# Access Compliance Report

### (Curb Ramps)

Intersection ID: 16526	Main Street: AMITY_PL	Cross Street: ASPENDALE_LN	Location: SE
ADA ID: 5BA60114C69A	Ramp Type: PerpDiag	Initial Pass/Fail: Fail	Overall Compliance: No
Severity Score: 33.75

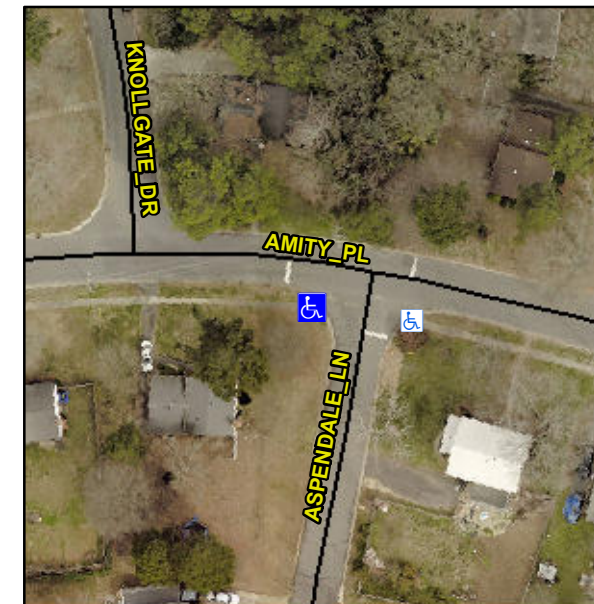
**Not Found, R304.5.1, R304.5.3**

Compliance	Description	Data	Compliance	Description	Data
N/A	Ramp Length (in)	52.0	Yes	Ramp Slope (%)	7.9
No	Ramp Width (in)	45.0	No	Ramp XSlope (%)	8.4
N/A	Flare Type LT	N/A	N/A	Flare Type RT	N/A
N/A	Flare Slope LT (%)	N/A	N/A	Flare Slope RT (%)	N/A
N/A	Flare Traversable LT?	N/A	N/A	Flare Traversable RT?	N/A
N/A	Landing Length (in)	N/A	N/A	DWS Provided?	N/A
N/A	Landing Width (in)	N/A	N/A	DWS Contrast?	N/A
N/A	Landing Slope (%)	N/A	N/A	DWS Length (in)	N/A
N/A	Landing X Slope (%)	N/A	N/A	DWS Full Width?	N/A
N/A	Landing Curb? (Y/N)	N/A	N/A	DWS Offset (in)	N/A
N/A	Shared Landing?	N/A			
N/A	Gutter Ponding?	N/A	N/A	Gutter Slope (%)	N/A
N/A	Gutter Lip Ht (in)	N/A	N/A	Gutter X Slope (%)	N/A
N/A	Painted X Walk1?	No	N/A	Painted X Walk2?	No
	X Walk 1 Direction	To E		X Walk 2 Direction	To N
N/A	X Walk 1 Width (in)	N/A	N/A	X Walk 2 Width (in)	N/A
	X Walk 1 Slope (%)	0.2		X Walk 2 Slope (%)	6.4
	X Walk 1 X Slope (%)	5.3		X Walk 2 X Slope (%)	2.7

**Remove & Replace Curb Ramp With Two New Directional Ramps or Equivalent.**
